## Minutes: Minnesota Committee on Uniform Traffic Control Devices

July 8, 2020 1:00 – 3:00

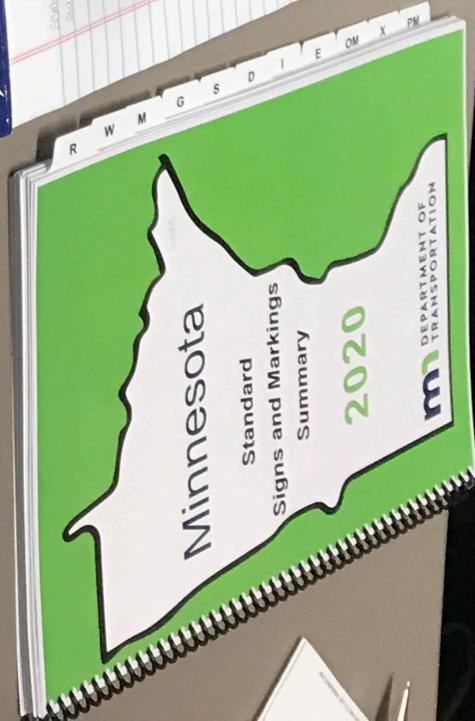
- Who is using the cylindrical design – can the language be more general.
- Under the support section it talks about a cylindrical design and dimensions.
- Instead can it just reference a 360 degree reflective delineator?

- Instead of calling it a cylinder can we call it something else like a wrap around – a 360 degree reflective delineator.
- These can be wrapped around a square tube, u-channel post.
- Are they compliant with the fed manual? Is there a MUTCD compliant way to do the delimitation?
- It is a stand-alone delineator – not an enhanced conspicuity device.
- Skeptical of newer square style vs delineator that has more surface area for reflectivity.

**Action Item:** Josie and Tiffany will make the language more general and bring back to the group. Photos of delineators are attached.
